Lot 2 (No. 640) South Western Highway. Byford / Amendment to Byford District Structure Plan Urban Development to Commercial / PA19/971

Ordinary Council Meeting - 20 April 2020

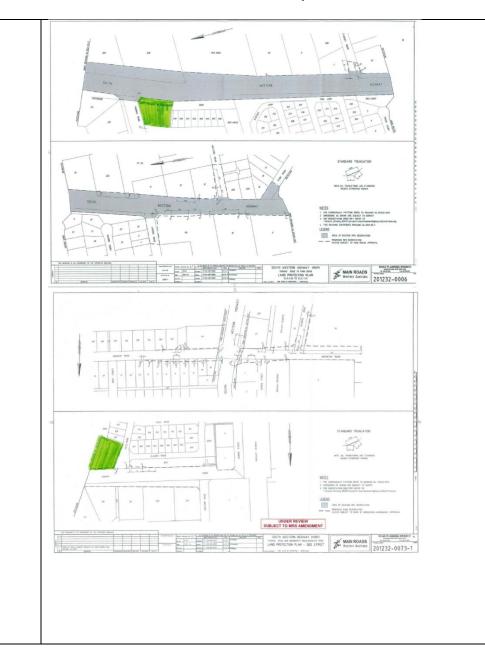
- In terms of future development adjacent to South Western Highway, it is important to be aware of the South Western Highway Access Strategy when considering any form of structure plan. The access plan is attached for your convenience. This plan has been developed in consultation with Council.

Highway Access Strategy (SWHAS) extracts provided MRWA appear to be dated December 2010. in any event, do not align with the planning framework as established the by existing Structure Plan. For example, properties identified by the Plan for Structure commercial activities (i.e. Town Centre. Neighbourhood Nodes) on the eastern side of South Western Highway are not identified as commercial on the SWHAS. Similarly, properties between Larsen Road and Evans Way are classified as Commercial' 'Highway under the Structure Plan. but shown as 'Public and Community Purposes' on the SWHAS plan. In this respect, the relevance and usefulness of the SWHAS in considering the proposed Structure Plan amendment questionable. The SWHAS extracts provide no meaningful

guidance or additional information relevant to proposed Structure Plan amendment for this site. The subject site is simply identified **'Urban** as Development' and confirms the alignment of adjacent road reserves. Contrary to assertions of MRWA, the proposal not inconsistent with Perth Peel@3.5million. and The subject site is simply identified as 'Urban' in Sub-Regional the **Planning** Framework. which can include a variety of residential, commercial and other activities. urban Furthermore. only Strategic Metropolitan, Secondary, District and Specialised activity centres are mapped at this regional/sub-regional level, with the location of lower order neighbourhood and local activity centres to be identified in local planning frameworks (including structure plans). It is not clear why MRWA
